Verify before backfill.

Below-grade wall assembly | Follow-up required

Original field photograph. Visible conditions only.

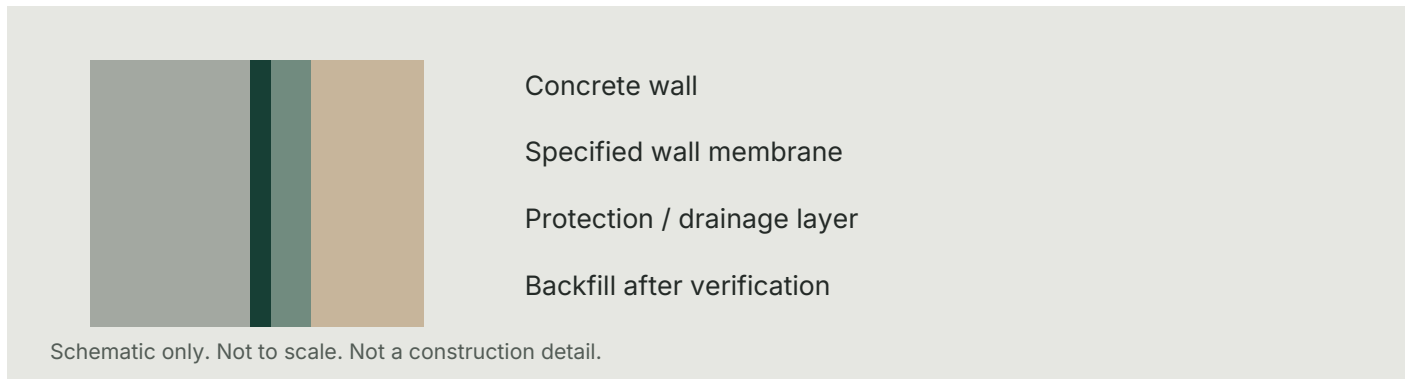
Black surface material covers the visible concrete wall faces. The adjacent excavation remains open.

The open excavation provides a chance to document the assembly before backfill conceals it.

The photograph does not identify the product or thickness, confirm wall-base drainage or establish the white pipe's purpose.

Completion evidence requested. Confirm the relevant assembly and records before accepting this scope as complete.

A coated wall does not substantiate every component in the example detail. Request the approved wall detail, product submittal and installation instructions. Match the visible stage to records of the work before concealment.

Contractor	Pre-backfill photographs of the base, corners, joints, protection layer and drainage connection; applicable inspection records.
Design team	Approved detail, submittal and clarification of any assembly changes.
Owner / reviewer	Prior and current pay applications, scope breakdown and documented resolution of remaining evidence gaps.
